# Access Compliance Report

## Public Rights-of-Way

### (Curb Ramps)

Intersection ID: 26362	Main Street: GLEN_SUMMIT_DR	Cross Street: WALCOURT_VALLEY_PL	Location: NW
ADA ID: BAFB14E5B2CE	Ramp Type: Perp	Initial Pass/Fail: Pass	Overall Compliance: No
Severity Score: 10			
Codes/Mitigation Info/Possible Solution		Field Measurements/Component Compliance

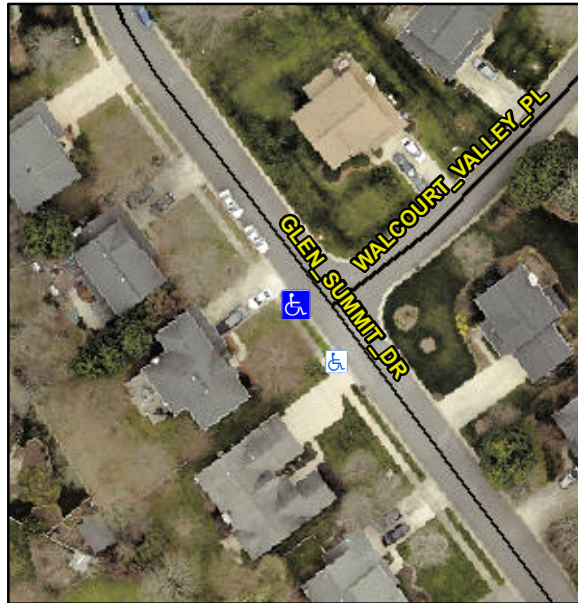
**Remove & Replace Entire Ramp.**

**R304.2.2-Perp, R304.3.2-Para, R305**
